CALIFORNIA COASTAL COMMISSION

Filed: January 14, 2003
49th Day: March 4, 2003
180th Day: July 13, 2003
Staff: KFS-LB *JS*
Staff Report: March 26, 2003
Hearing Date: April 8-11, 2003
Commission Action:

**RECORD PACKET COPY****STAFF REPORT: REGULAR CALENDAR****APPLICATION NUMBER:** 5-03-013**APPLICANT:** MT No. 1 LLC, Jim Johnson CEO and President**AGENTS:** Nancy Lucast, Lucast Consulting
Mark R. McGuire, Esq.**PROJECT LOCATION:** Northwest of the intersection of Avenida Pico and N. El Camino Real, City of San Clemente (Orange County)

PROJECT DESCRIPTION: Residential and commercial development, public park, trails and open space and associated infrastructure including roads and utilities on the 201.38 acre portion of the Marblehead property within the coastal zone. Included are a property subdivision and construction of 313 single family homes on 44.24 acres, 141,506 square feet of commercial space in ten commercial buildings on 22.3 acres, 15.43 acres of public parks; 95.04 acres of public and private open space and pedestrian and bicycle trails; 12.43 acres of private streets; 10.91 acres of public streets; more specifically described in Section II.A. of this staff report. The

EXHIBIT 19c

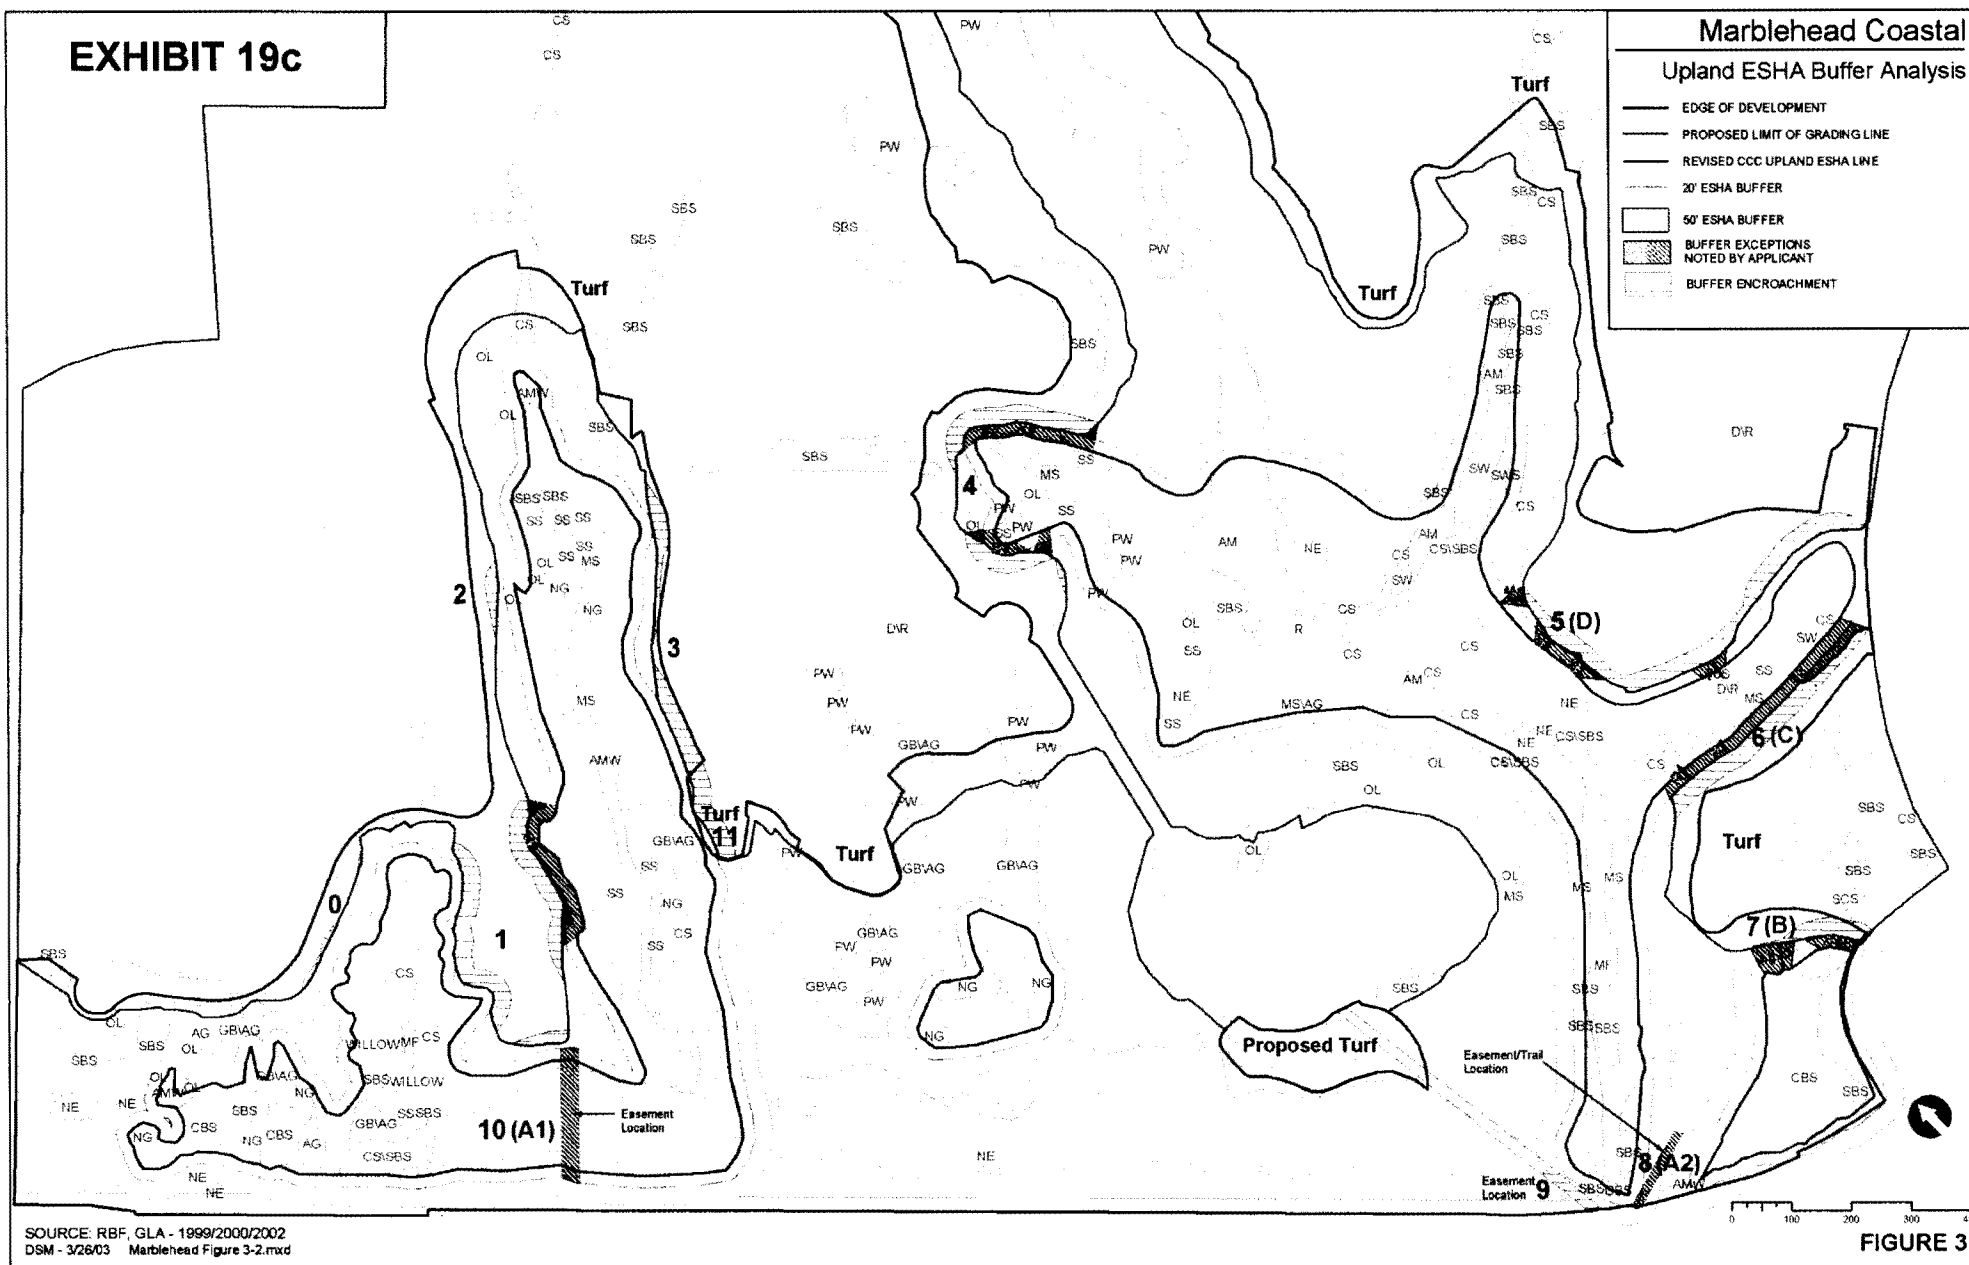
I also considered revising the ESHA designation in the vicinity of the western canyons to exclude the connecting corridor between them (in the vicinity of location 10 (A1) in Figure 3) because of the general lack of native vegetation and the fact that the observed main use areas were the canyons themselves. Were this approach used to designate ESHA boundaries in this area, the connecting area would still have to be protected as a buffer or wildlife corridor in order to comply with section 30240(b) of the Coastal Act. However, upon reviewing the report of the original field work, I have elected not to alter the ESHA boundary in this area in order to maintain consistency in the protocol used to designate ESHA throughout the Marblehead site. This decision is largely based on the following observations made by the biologists (Natural Resource Consultants) that estimated the gnatcatcher "occupied habitat" area in 1997: "This pair was located in the southwestern corner of the site and was observed to use two small drainages separated by the coastal bluff along the southern edge of the site." "...[T]he graded bluff...supports disturbed or ruderal habitat covered by introduced iceplant." and "...supports scattered saltbushes used by this pair as they forage westward to the western drainage. The gnatcatchers are not simply using the bluff as a fly-over link but are actively foraging there, at times taking 30 minutes to cross the approximately 500 feet separating the two drainages. During NRC's November surveys the same isolated saltbushes were used each day as the birds traveled across the bluff between the east and west drainage." The character of the vegetation apparently has not changed since 1997 and retains the same potential for gnatcatcher use.

The proposed plan includes encroachment of grading or permanent development into the recommended ESHA or ESHA buffer at several locations. The applicant requests exceptions to the ESHA and ESHA buffer policies in these areas. The locations of the proposed buffer encroachments are shown in Figure 3. They include narrow buffers within encroachment areas shown in Exhibit 1 to Jim Johnson's March 7, 2003 letter to Karl Schwing (red hatched areas) and additional encroachment areas identified by staff (green hatched). They are discussed by number below.
